EMERGENCY ALERT SERVICE BULLETIN

SUBJECT: ENGINE CONTROLS - Twist grip

Functional check and installation of a protection for micro-contacts 53Ka and 53Kb and 65K (IDLE / FLIGHT mode)

AIRCRAFT CONCERNED	NUMBER	Version(s)	
		Civil	Military
AS350	05.00.61	B3	
AS550	05.00.41		C3
EC130	05A009	B4

Figure 1

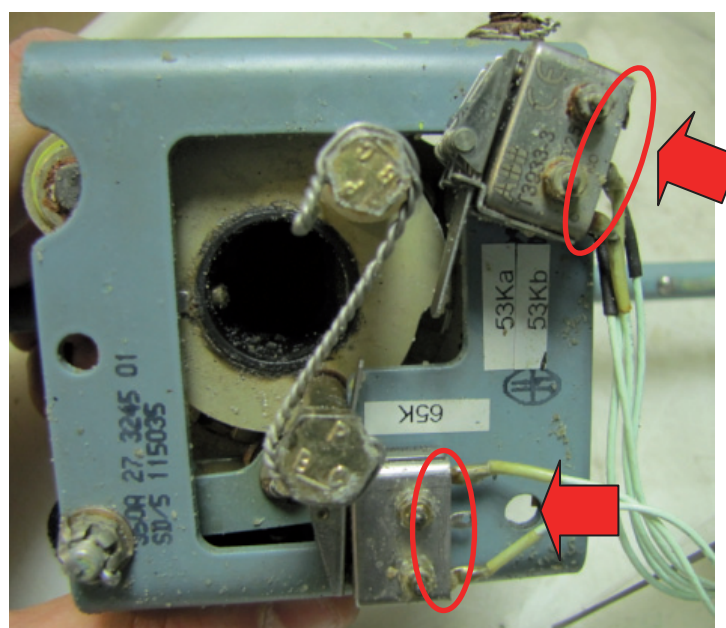
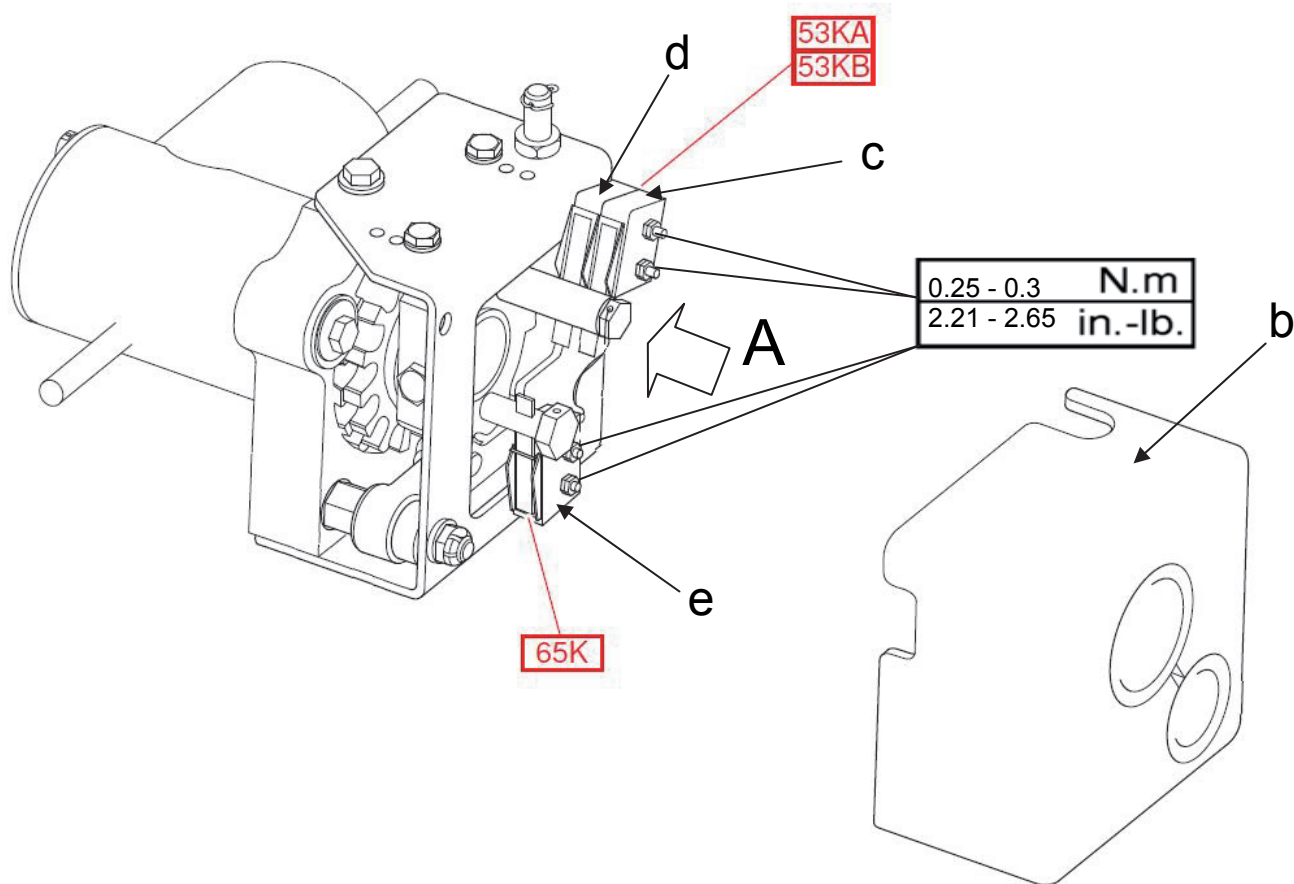
- Remove the lower front cowl as per AMM Task 53-51-00, 4-2.
- Remove the protective cowl (b).
- Inspect the wiring side of micro-contacts (c), (d) and (e) in order to ensure that there are no marks, residues or corrosion (DETAIL A - Figure 1).
- If there are marks, residues or corrosion, comply with paragraph 3.B.2.
- If there are no marks, residues or corrosion, comply with paragraph 3.B.3.

Figure 2: Electrical continuity test of micro-contacts 53Ka, 53Kb and 65K

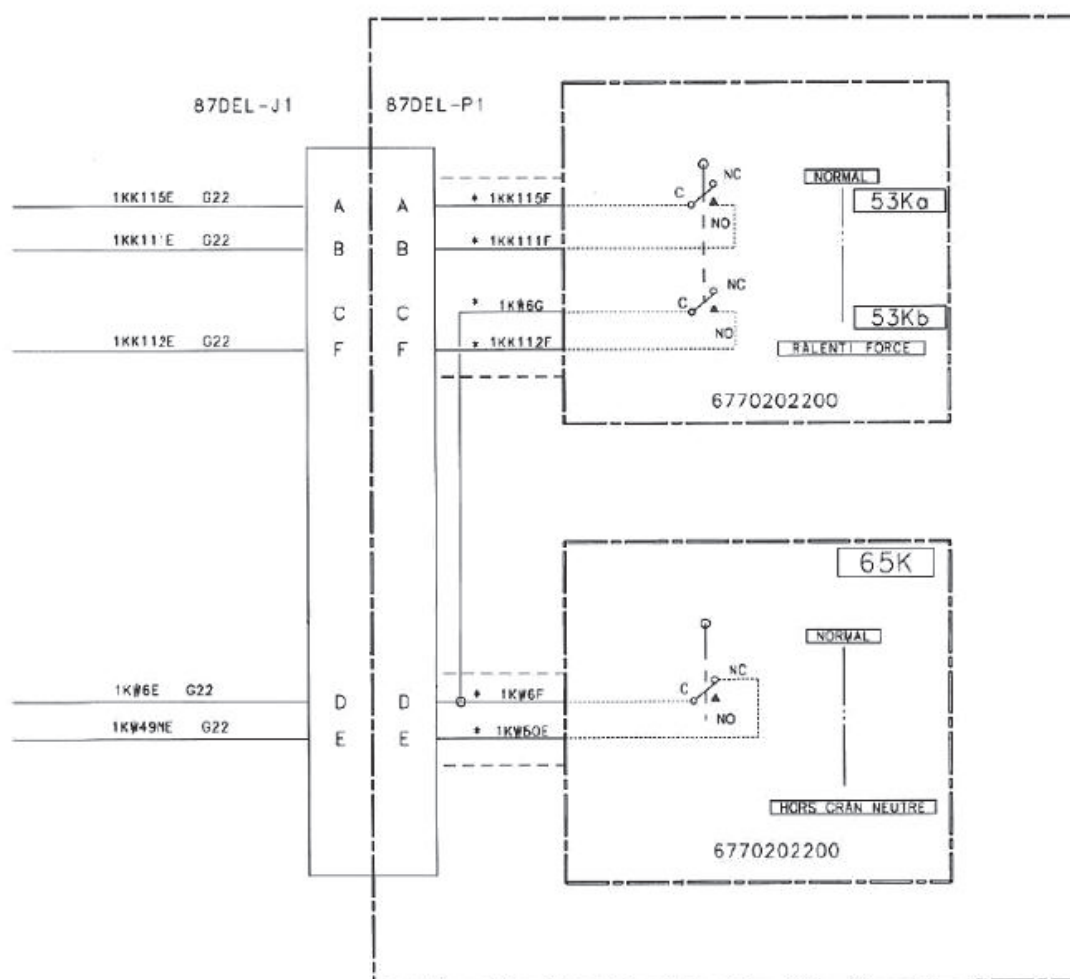
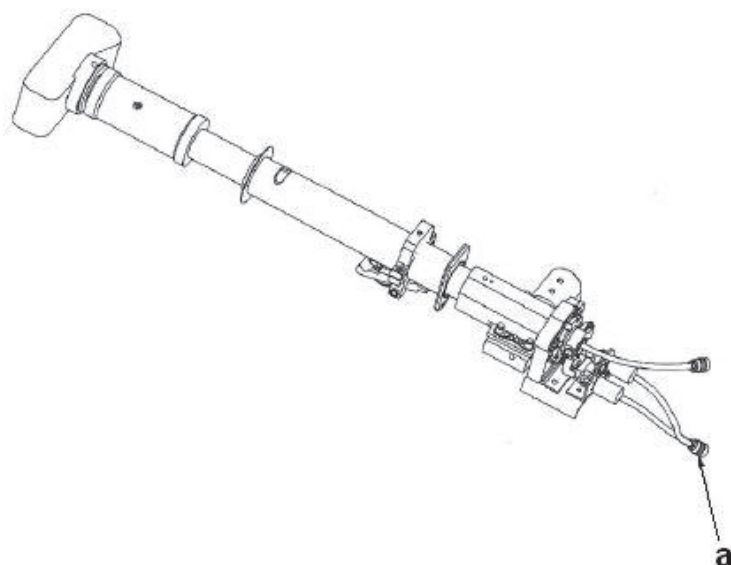
- Connect an ohmmeter (yy) to terminals A and B of micro-contact 53Ka.
- Turn the twist grip from "IDLE" to "FLIGHT" and from "FLIGHT" to "IDLE":
 - . Check on the ohmmeter (yy) that the micro-contact closes in the "IDLE" position and opens as soon as the twist grip is turned from the "IDLE" position to the "FLIGHT" position.

- Disconnect the ohmmeter (yy) and connect it to terminals D and F of micro-contact 53Kb.
- Turn the twist grip from "IDLE" to "FLIGHT" and from "FLIGHT" to "IDLE":

- Disconnect the ohmmeter (yy) and connect it to terminals D and E of micro-contact 65K.
- Turn the twist grip from "IDLE" to "FLIGHT" and from "FLIGHT" to "IDLE":

- . If the check result is not correct, replace the concerned micro-contact as per AMM Task 76-12-03, 4-1 (AS350 and AS550) or 76-12-03, 4-1b (EC130).

- . If the check result is not correct, replace the concerned micro-contact as per AMM Task 76-12-03, 4-1 (AS350 and AS550) or 76-12-03, 4-1b (EC130).

- . If the check result is not correct, replace the concerned micro-contact as per AMM Task 76-12-03, 4-1 (AS350 and AS550) or 76-12-03, 4-1b (EC130).

Figure 3

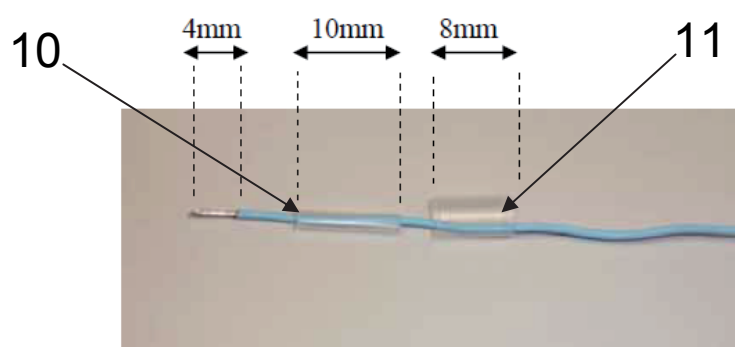
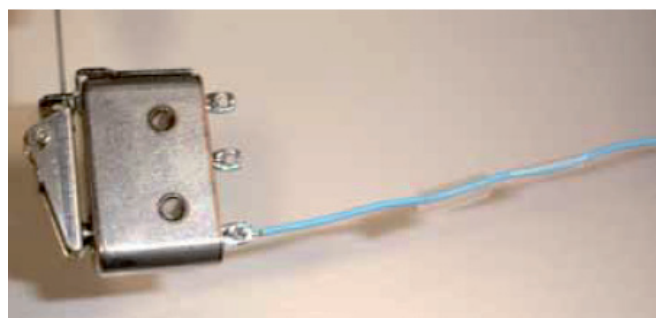
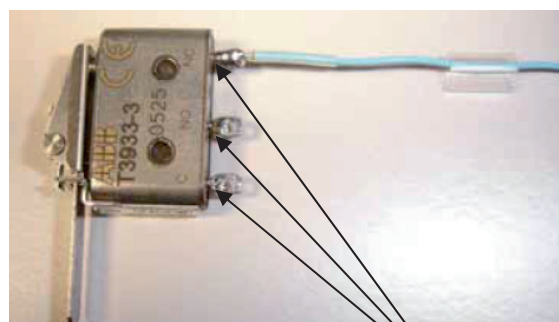
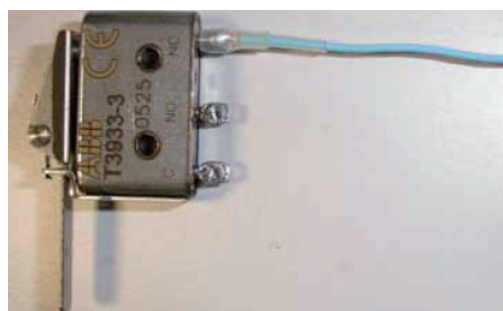
- Strip and tin the wires over a length of 4mm: Detail B.
- Position two pieces of sheath: one 10 mm piece of sheath (10) and one 8mm piece of sheath (11): Detail B.
- Preform the wire strands into a hook shape: Detail C.
- Position the preformed wire strands in the contact hole of the micro-contact: Detail D.
- Weld using a welding iron set to 340°C (tolerance -15°C to +30°C): Detail E.
- Apply varnish (12) with a brush to the welds of the electrical terminals and unused terminals to protect them from corrosion. Comply with MTC Work Card 20.04.03.103 without oven-drying the component: Detail E.
- Leave to dry until the varnish hardens.
- Position the sheath (10) up against the weld and shrink fit it: Detail E.

- Position the sheath (11) up against the micro-contact and shrink fit it: Detail F.

- If varnish is absent or flaky, apply varnish (12) with a brush to the welds of electrical terminals and unused terminals to protect them from corrosion. Comply with MTC Work Card 20.04.03.103 (MTC) without oven-drying the component: Detail E.
- Leave to dry until the varnish hardens.
- Position the sheath (10) up against the weld and shrink-fit it: Detail E.
- Position the sheath (11) up against the micro-contact and shrink-fit it: Detail F.
- Comply with paragraph 3.B.6.
